Re: Nexus Brewery, 4730 Pan American Freeway NE Suite D, Permanent Certificate of Occupancy – Transportation Development Architect's Stamp dated 08-12-11 (F16-D002) Certification dated 08-12-11

PROJECT: Nexus Brewery

Re: Nexus Brewery, 4730 Pan American Freeway NE Suite D,

Nexus Brewery, 4730 Pan American Freeway, Traffic Circulation Layout Architect's Stamp dated 01-12-11 (F16-D002)

NEXUS BREWERY 05/20/11
.0848 = 11.8 2 11 = 12.7
#\$ 0.085586" = 11.68°
9/2"
9'-71
ADA Ramo
$\int_{\mathcal{A}} \int_{\mathcal{A}} \int$
John John

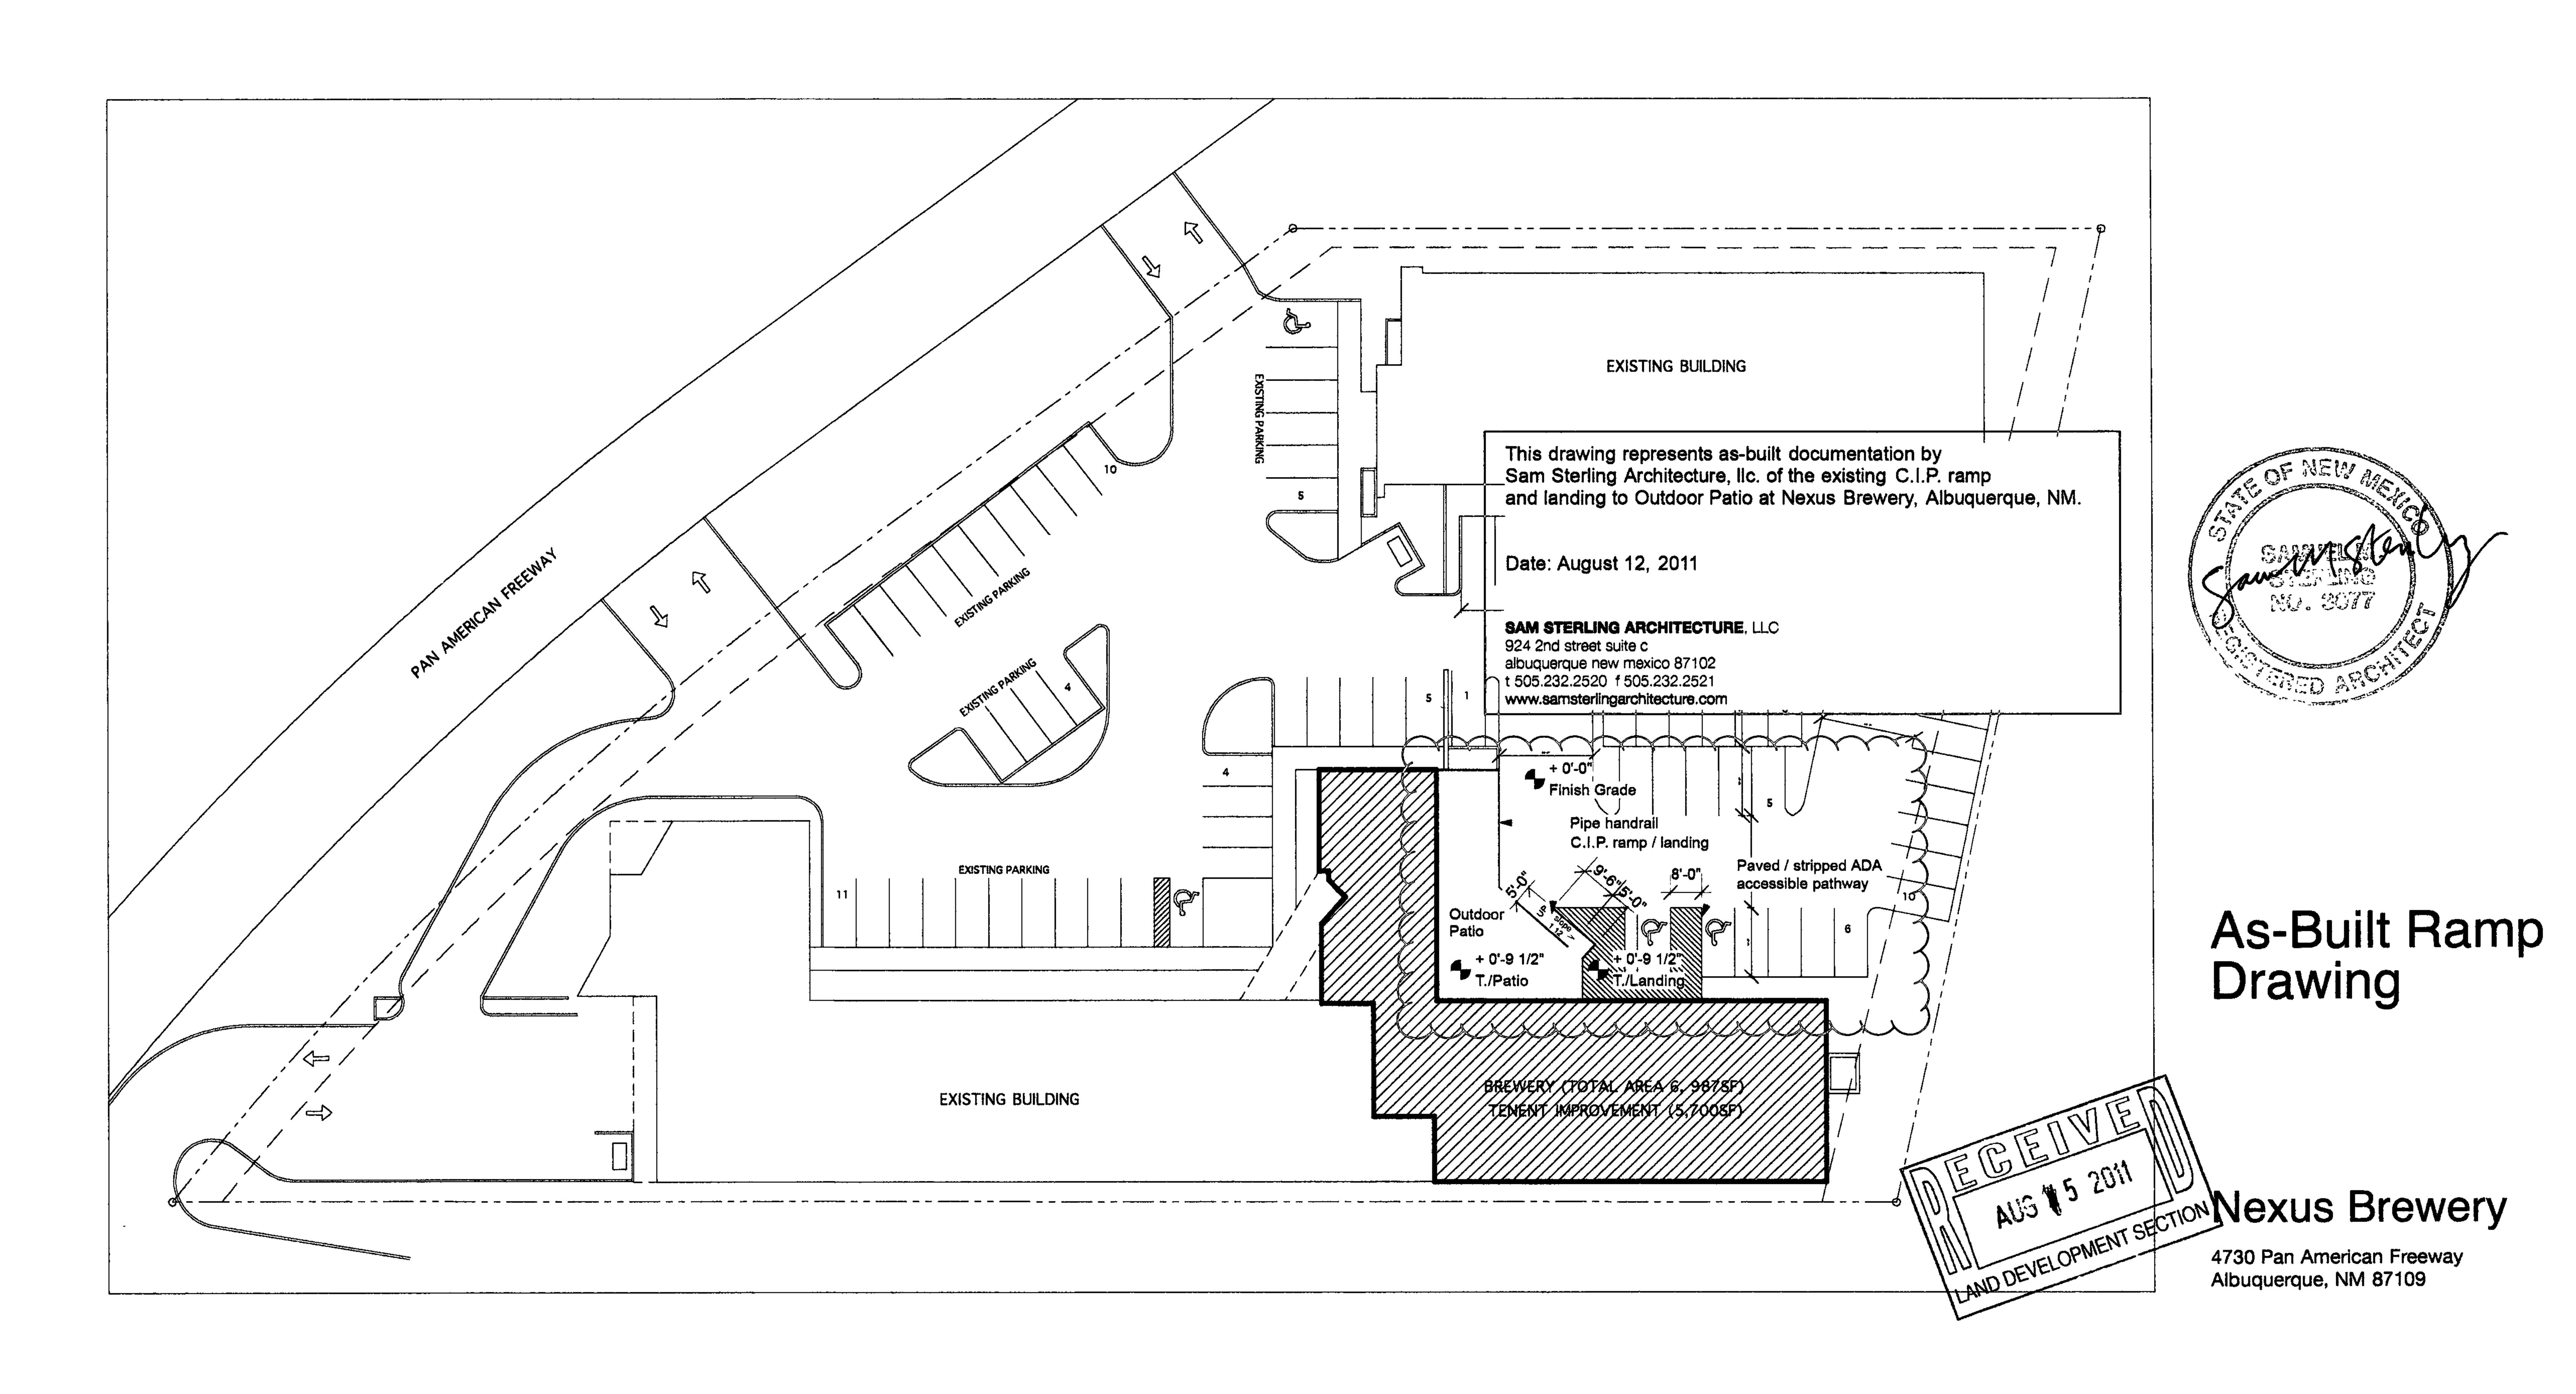
- The six-foot wide, ADA accessible pathway from the handicapped parking stalls to the building must be smoothly paved and clearly striped, as shown on the approved traffic circulation layout.
- The ramp built at the entrance of the Brewery was not built to the approved plan. Please show the revised ramp on the plan at resubmittal.
